Memorandum – Unified Development Review

To: City Plan Commission
From: Brianna Valcourt, M.Arch | Senior Planner
Date: June 25, 2025
RE: 199 Gladstone Street Subdivision: 199 Gladstone Street – Assessors Plat 8/3, Lot 90
Application for Dimensional Variance

AMENDED 8/5/25

EXISTING CONDITIONS PLAN

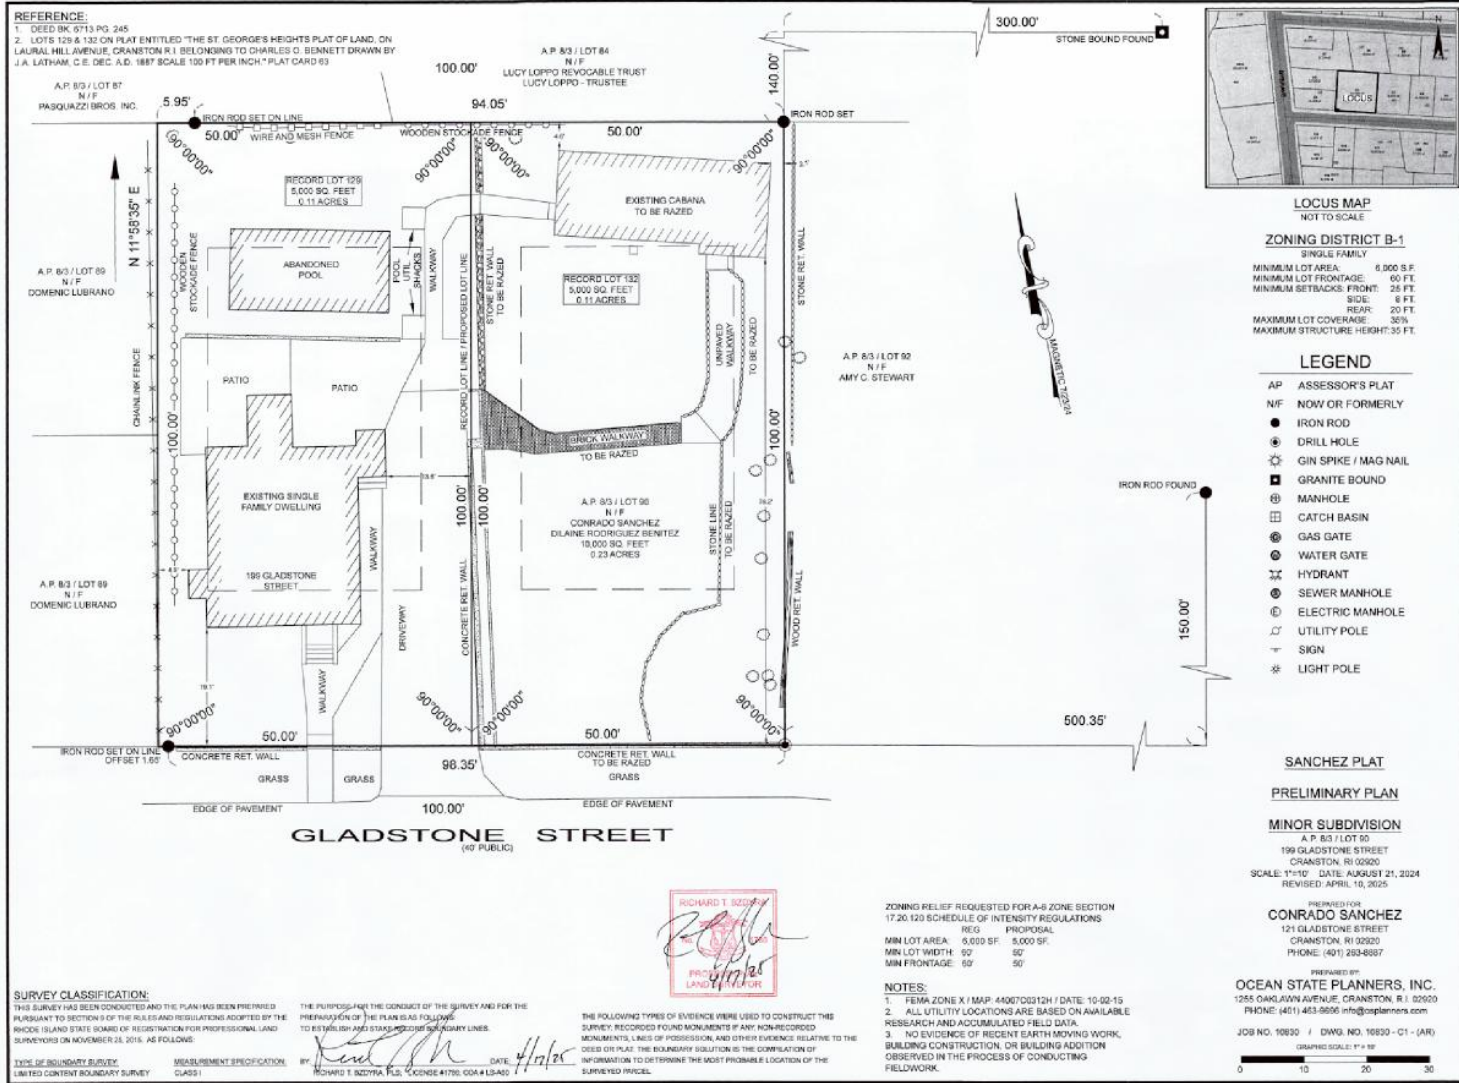
- Staff note that the location of the single-family home off center on the lot is consistent with plans to add a second house at a future time.

- Staff note that the variances and subdivision are required to allow an additional home to be built on the property.

1. **Lot 129**, with the existing single-family house, will be granted zoning relief to have a lot size of 5000 sq. ft. where 6000 sq. ft. is required and be granted relief to have 50’ of frontage where 60’ is required.
2. **Lot 132** will be granted zoning relief, for a new single-family structure, to have a lot size of 5000 sq. ft. where 6000 sq. ft. is required and be granted relief to have 50’ of frontage where 60’ is required.
